Registry No. H12063

General Locality Chatham Strait

Sublocality Southern Tebenkof Bay

Revisions and Corrections Compiled During Office Processing and Certification

Figure 9: Sound speed casts in southeast Explorer Basin acquired on DN 283 by Launch 2808. Launch 2808 lines, with SV artifact, are highlighted in yellow.

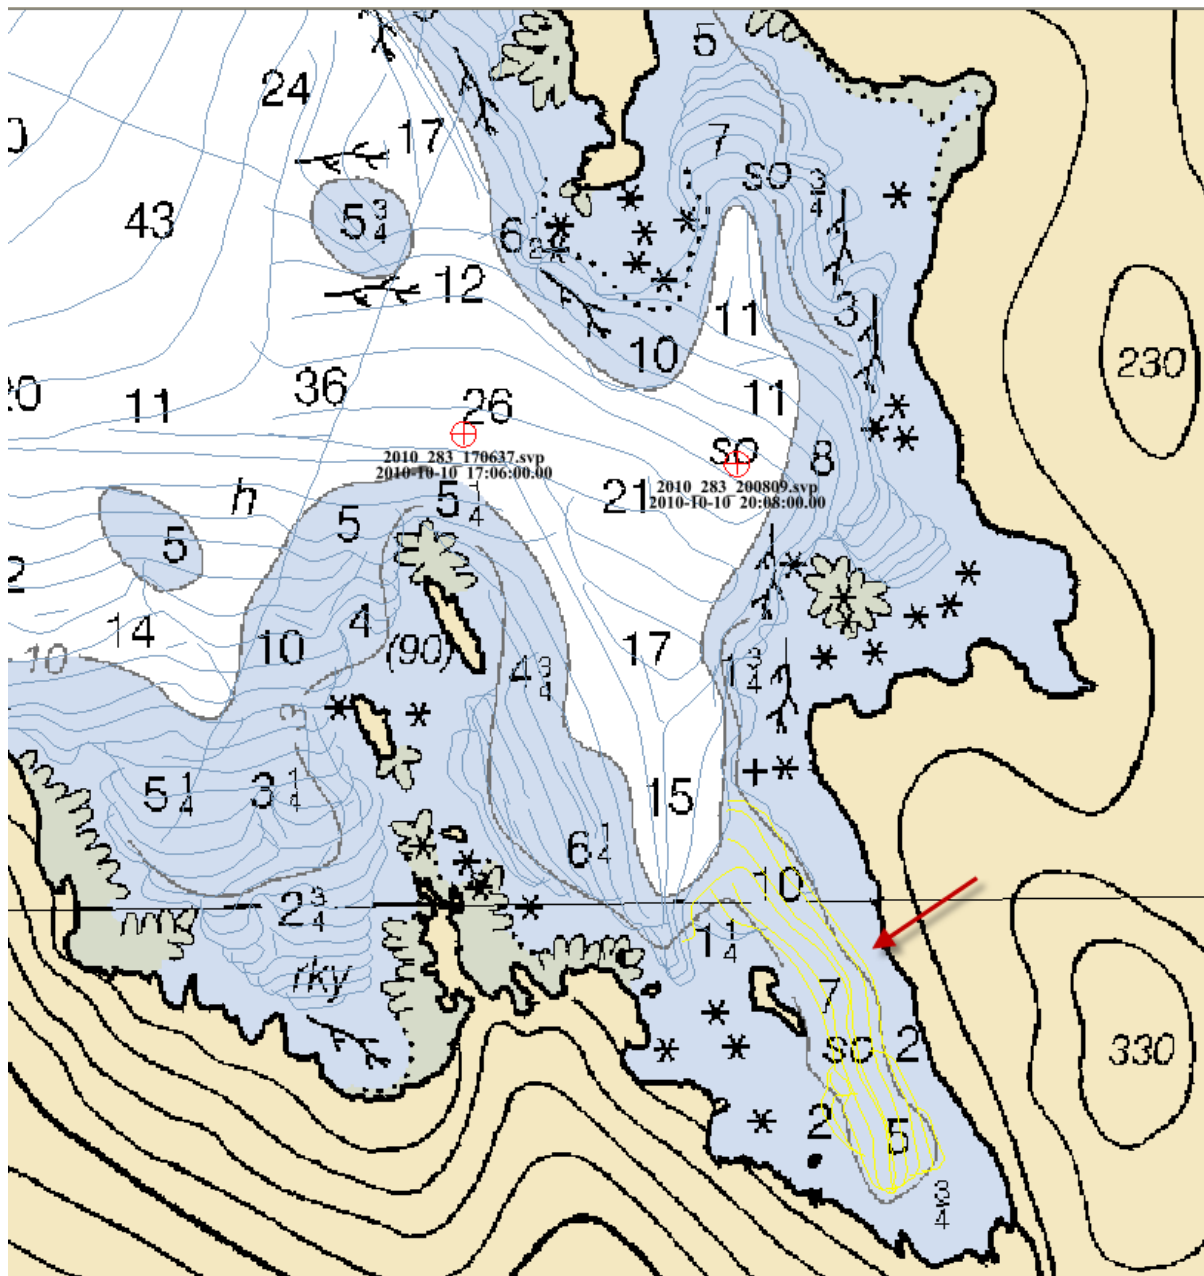
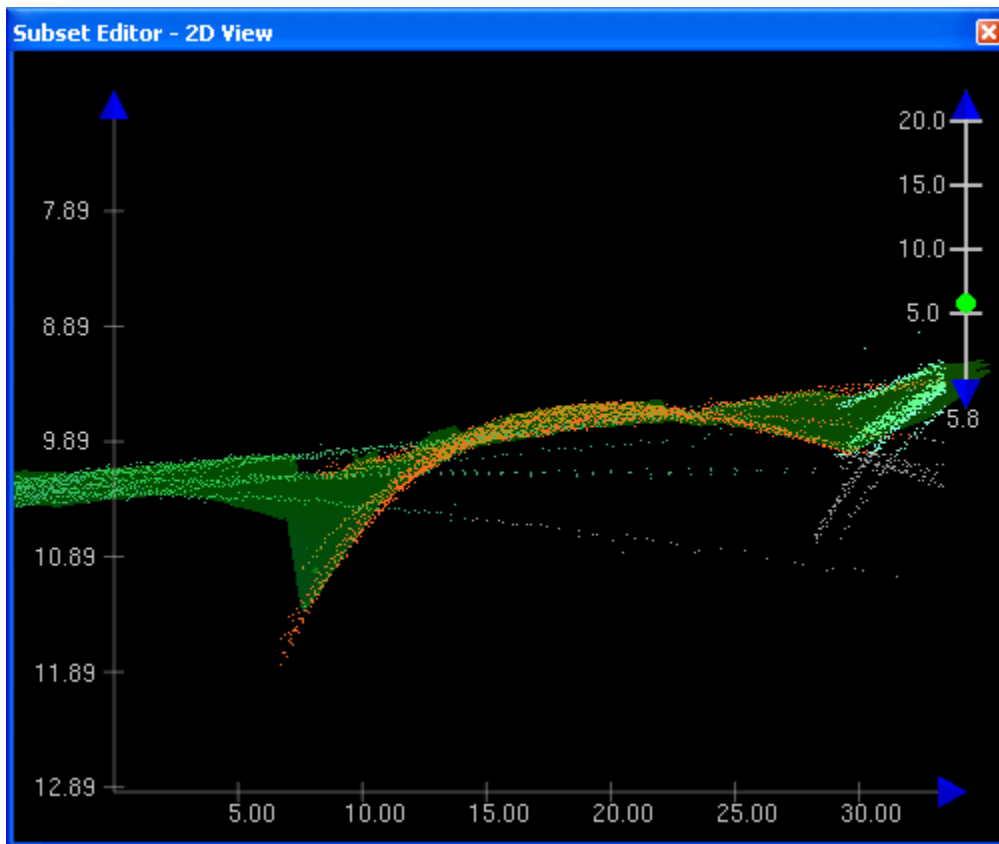
On DN 283 Launch 2808 acquired MBES data in the southeast portion of Explorer Basin but did not take an SVP cast which resulted in sound speed artifacts exclusively in the southeast portion of Explorer Basin. Casts 2010_283_170637 as well as 2010_283_225319 collected by Launch 2806 on DN 283 were both applied on separate occasions to localized lines (Figure 9), but the SV artifact was not resolved (Figure 10). The concatenated file from Launch 2808 was reapplied to launch lines. Generally the depth ranges from eight to twelve meters. The areas were manually cleaned in CARIS Subset Editor to remove all spurious soundings. Refraction artifacts of up to seven meters were seen between outer beams. Despite this issue the Hydrographer feels the soundings are adequate to supersede charted soundings in this area.¹⁰

¹⁰ Concur with clarification. During the Survey Acceptance Review, the lines in Explorer Basin were filtered to reject data beyond 5 degrees to both port and starboard to bring the data within the specified SV error budget. The remaining data meets specifications, however, holidays were left as a result of the filtering. These holidays were deemed navigationally insignificant given the gently sloping nature of the immediate area and therefore were not preserved in the HCell coverage.

Figure 11: Sound speed casts for Launch 2807 acquired by 2806 in adjacent bay on DN 278. Launch 2807 lines are highlighted in yellow.

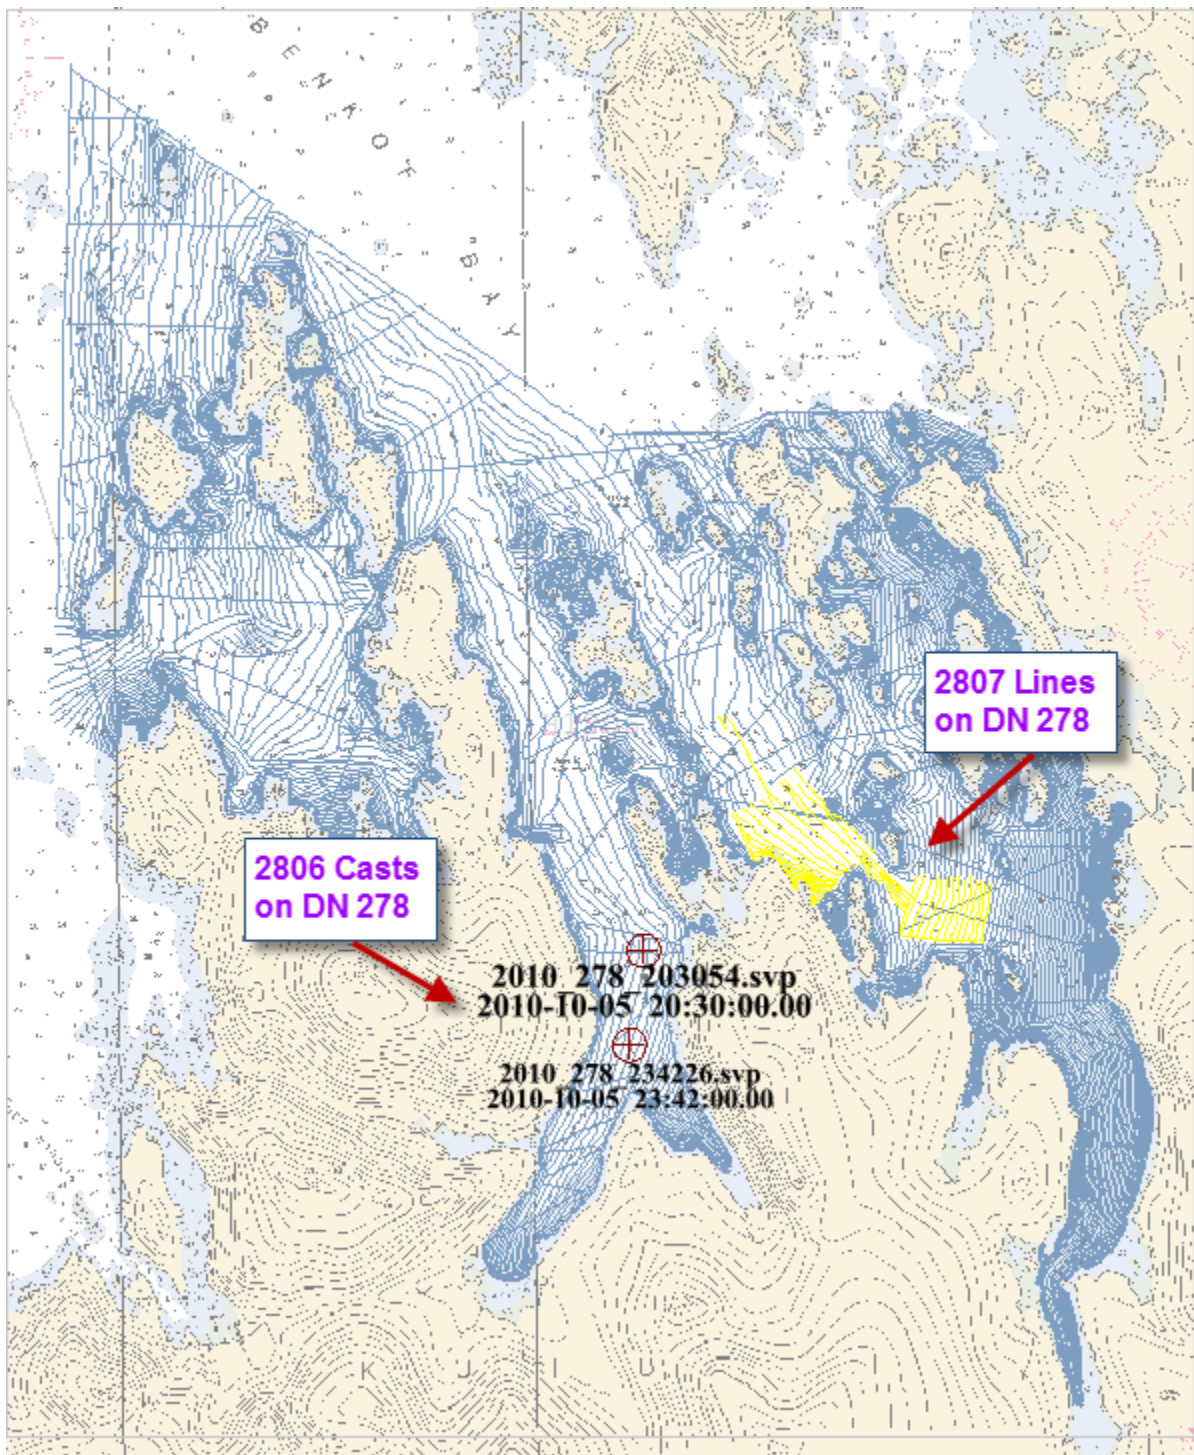
On DN 278 the CTD aboard Launch 2807 was inoperable so the concatenated SVP file acquired from Launch 2806 was used to correct Launch 2807's MBES data acquired on DN 278. Launch 2806 acquired CTD casts in the adjacent bay on DN 278; Thetis Bay (Figure 11). The method of Nearest in Distance within Time (3 hours) was used to process Launch 2807's DN 278 lines successfully.¹¹

¹¹ Concur with clarification. The data is adequate for charting.

Figure 12: Navigationally significant feature creating holiday east of East Island missing the top of the rock which does not have the least depth represented.

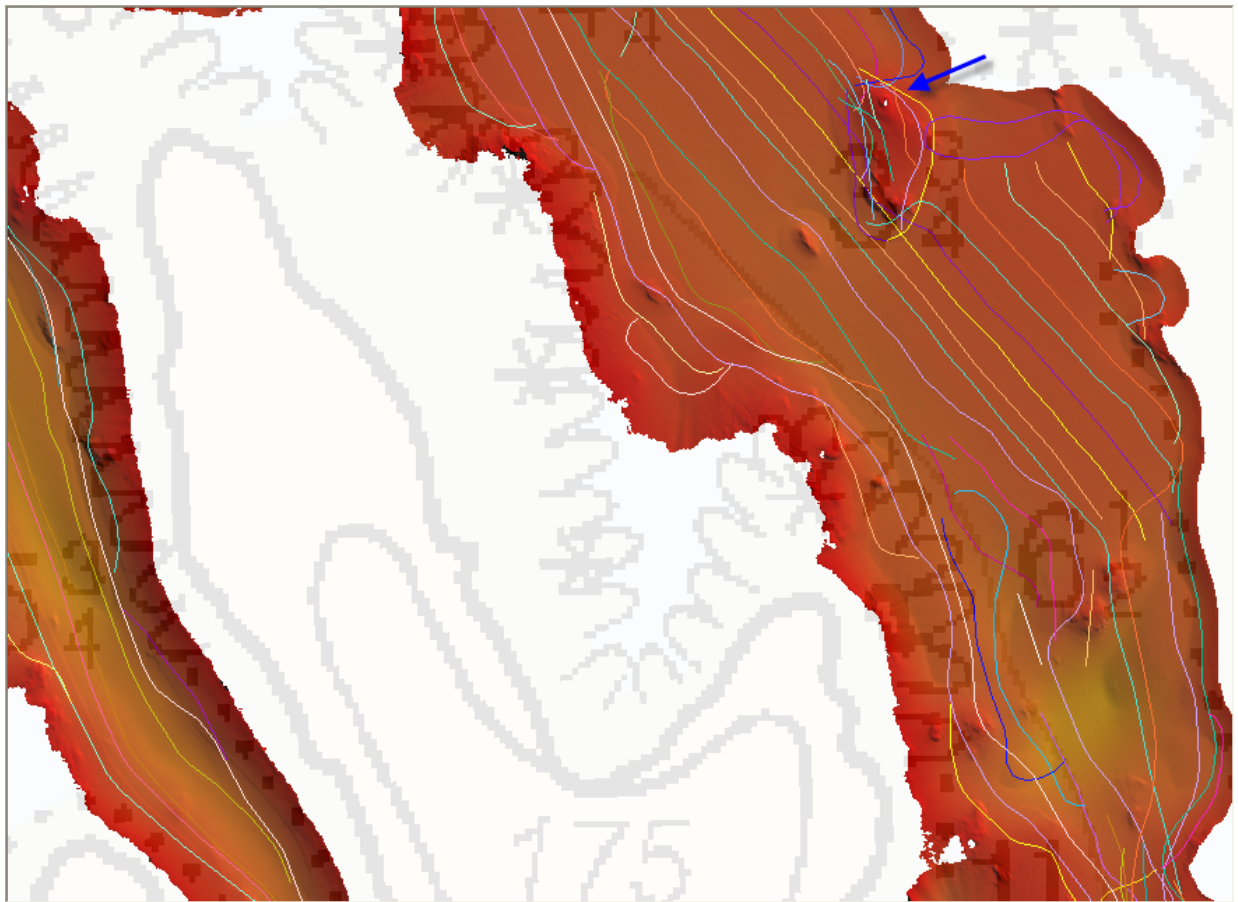
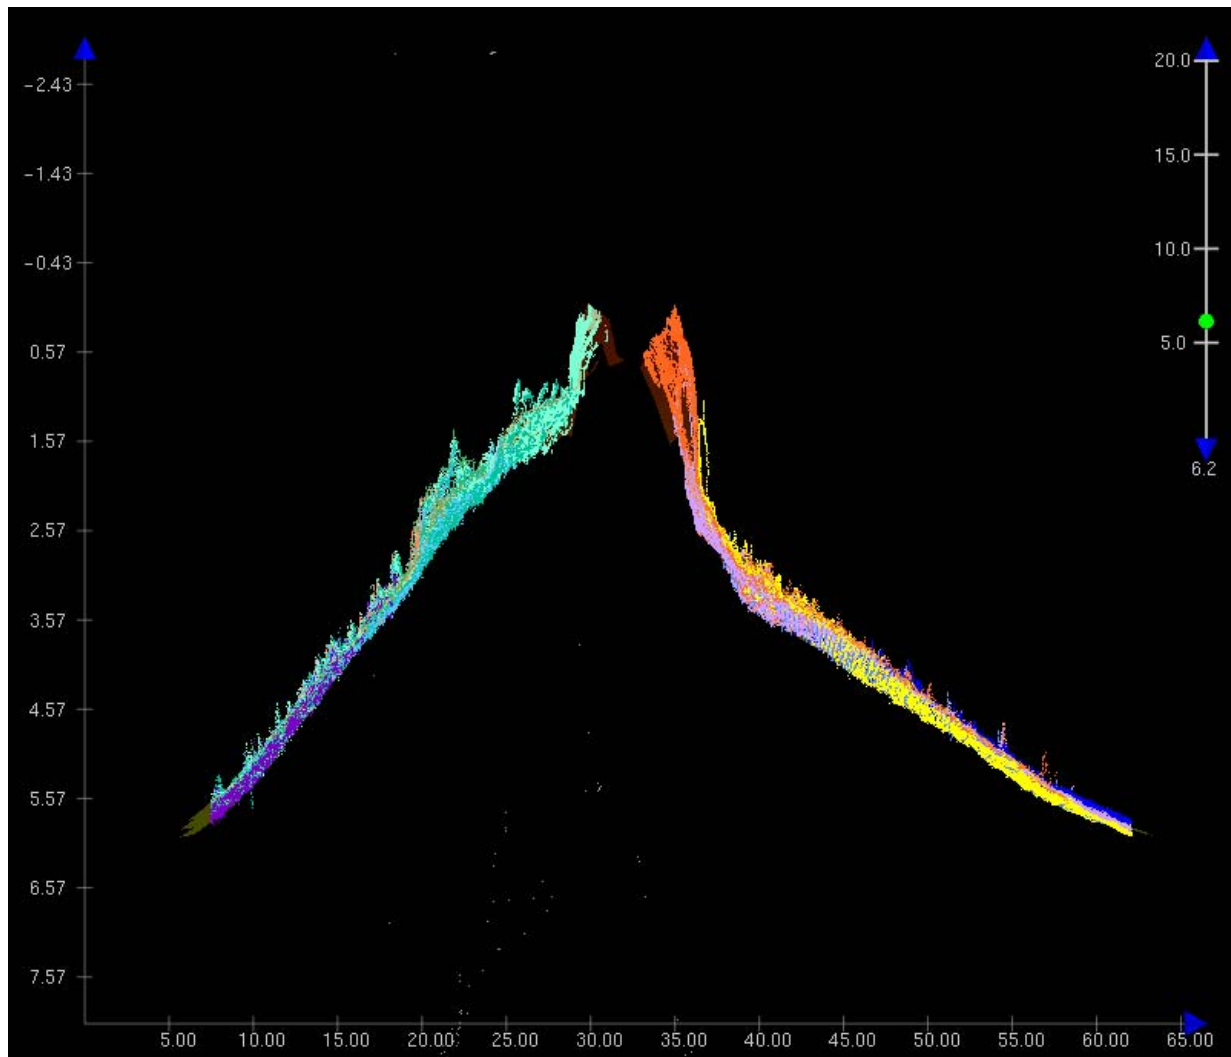
The navigationally significant feature not represented was due to a holiday created on the top of a rock by line spacing being too far apart east of East Island (figure 12 and 13). On the last day of field operations MBES data acquisition was attempted over the rock but was unsuccessful due to low tides at the time of acquisition.¹⁴

¹⁴ The rock, located at 56-25-58.54N, 134-03-57.93W, was reported as a DTON and has been applied to the chart. It is included in the HCell as a rock awash with unknown depth, and is located inside a newly defined foul area.

Figure 14: Line spacing too far apart creating holiday southwest of Oyster Rock has the least depth represented.

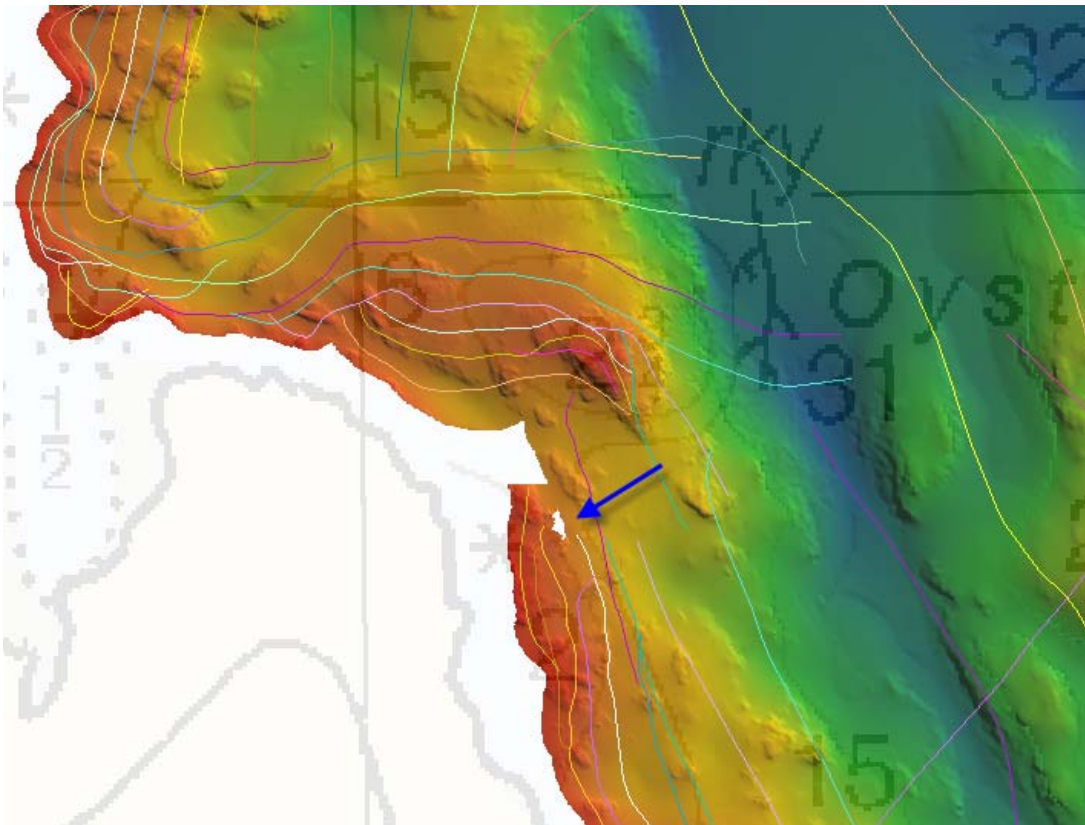
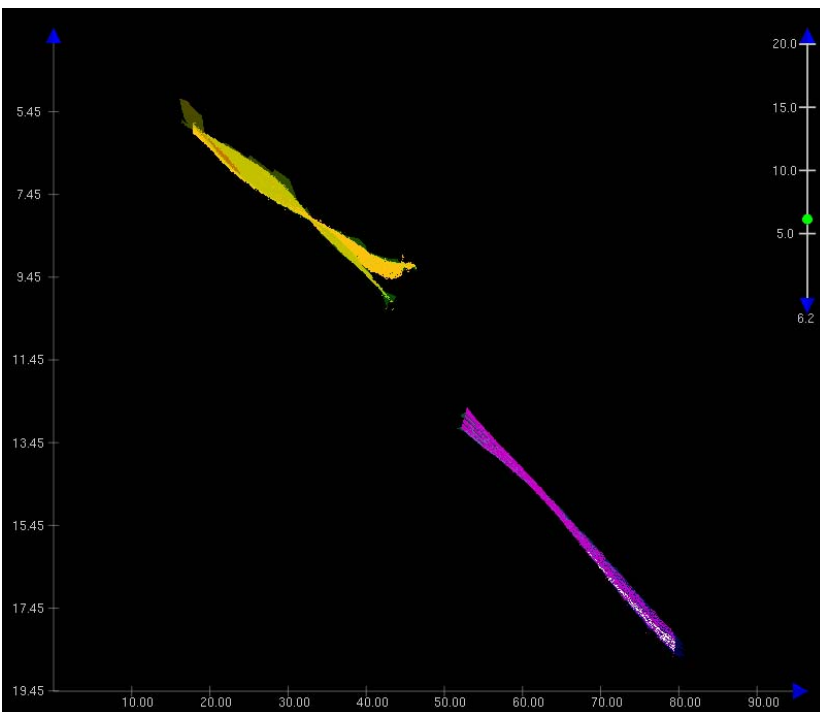
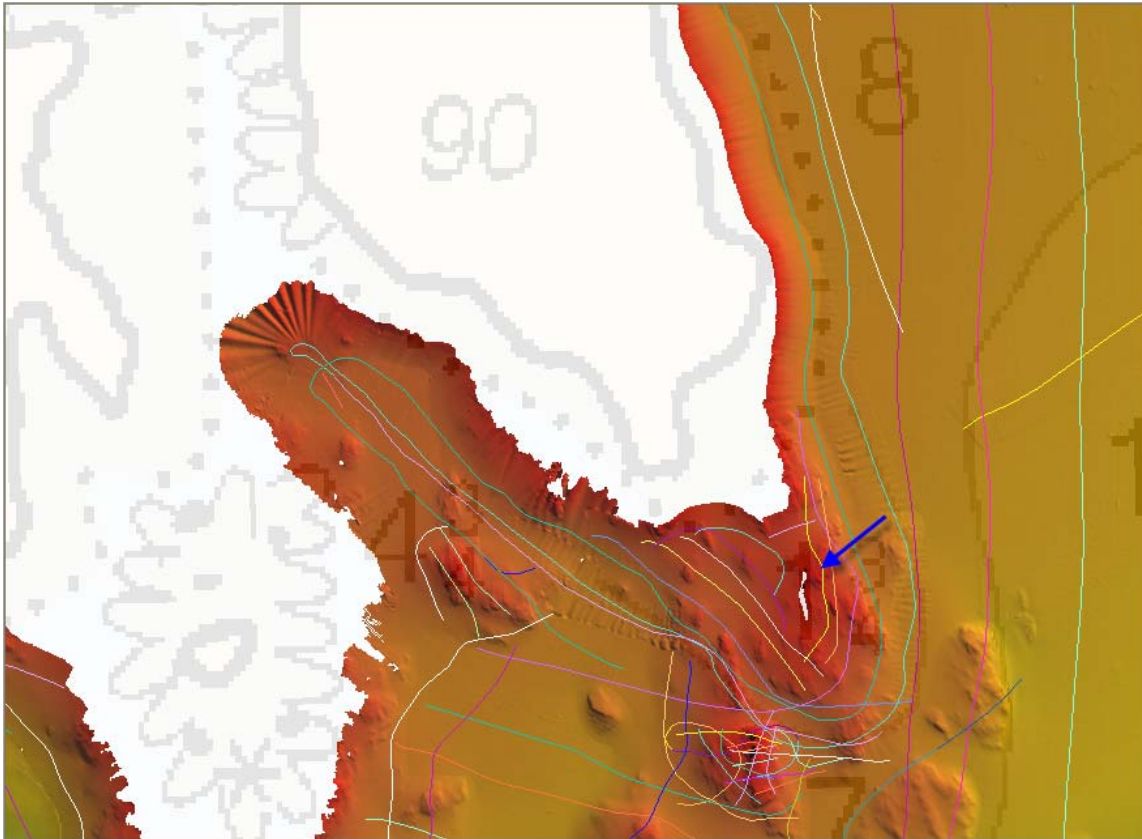
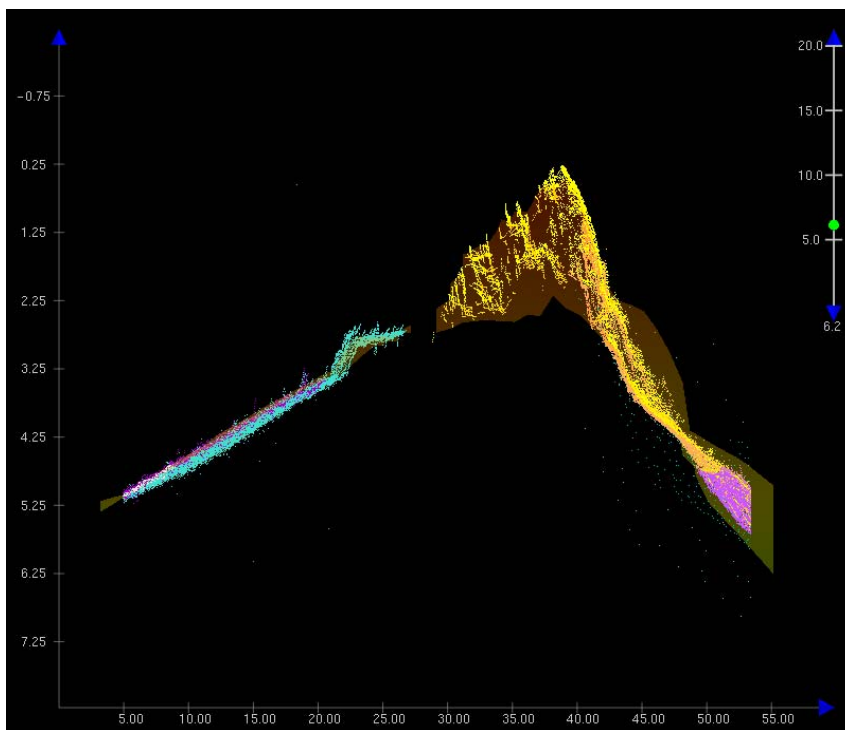
Two other holidays were created due to line spacing being too far apart; one southwest of Oyster Rock (Figures 14 and 15) and another being inside a new foul area south of a small islet SSE of Step Island (Figures 16 and 17). Both holidays are in areas where the seafloor surface trend was sloping downward so the Hydrographer believes the least depth is accurately represented.¹⁵

¹⁵ Concur with clarification. Due to the fact the holidays are on a slope and there was shoaler data acquired upslope of the holidays, the holidays are navigationally insignificant at chart scale.
